Reference: Innovus
Application Number: DA-2241-05
Case Number: 2023-6006-00; 2023-3005-00

Thank you for your review of the Innovus Site Plan Submittal. Please see below for a response to your review comments:

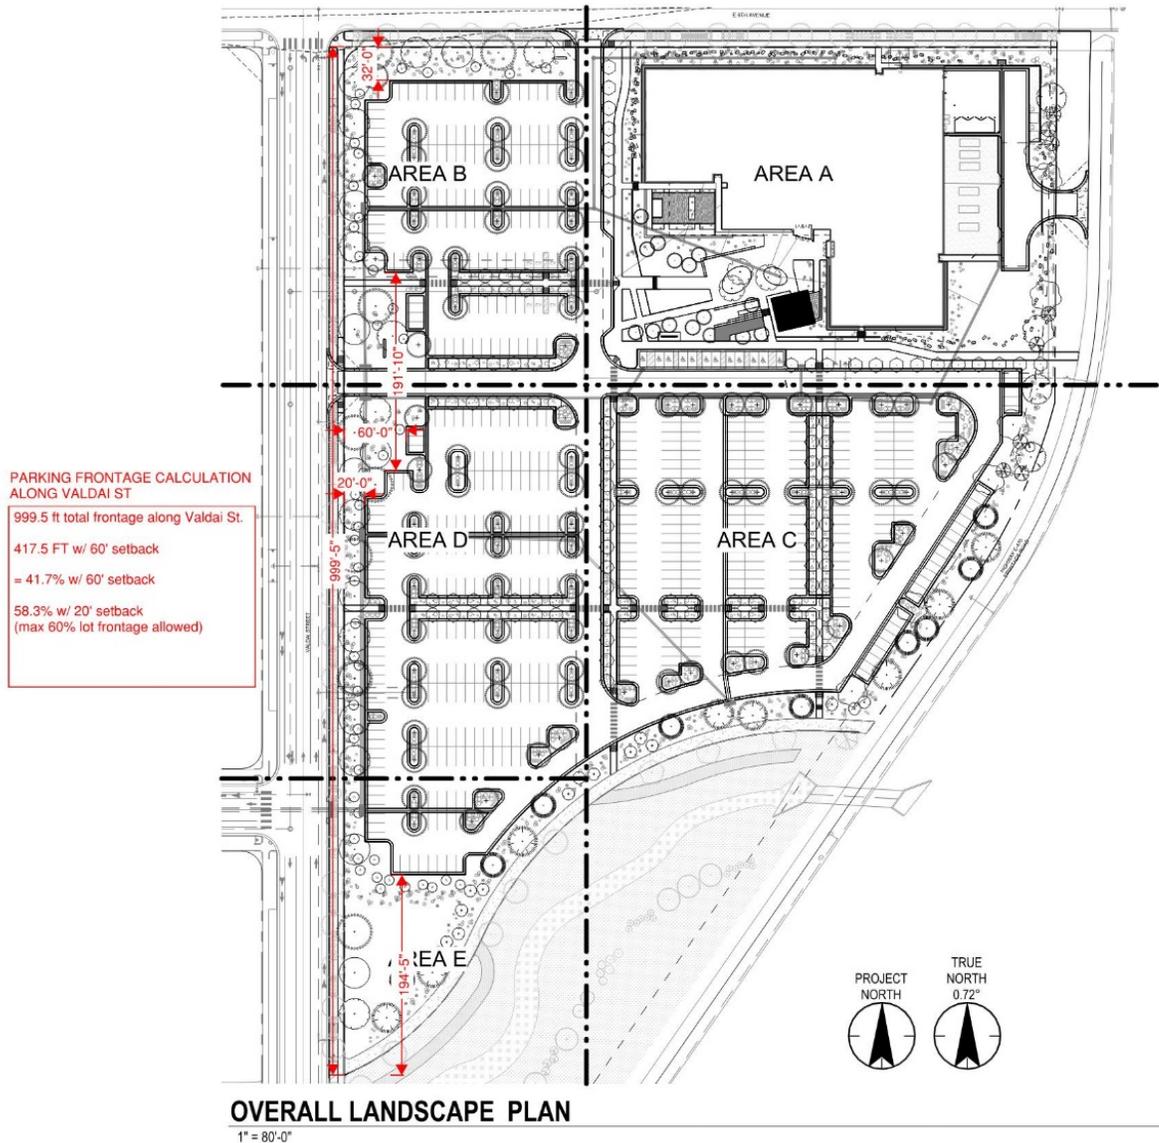
3B. No more than 60 percent of the lot frontage on arterial and collector streets to a depth of 60 feet shall be occupied by surface parking. Please refer to Code Section 146-4.6.5 of the UDO. The current iteration of the parking frontage along Valdai does not meet this code requirement. Please request an adjustment to this code section with your next submittal if the current arrangement will not change. Include justification for this adjustment request within the Letter of Introduction.

3B RESPONSE: The parking lot configuration along Valdai currently provides over 40 percent of the lot frontage with a 60 foot setback. Please see exhibit below.
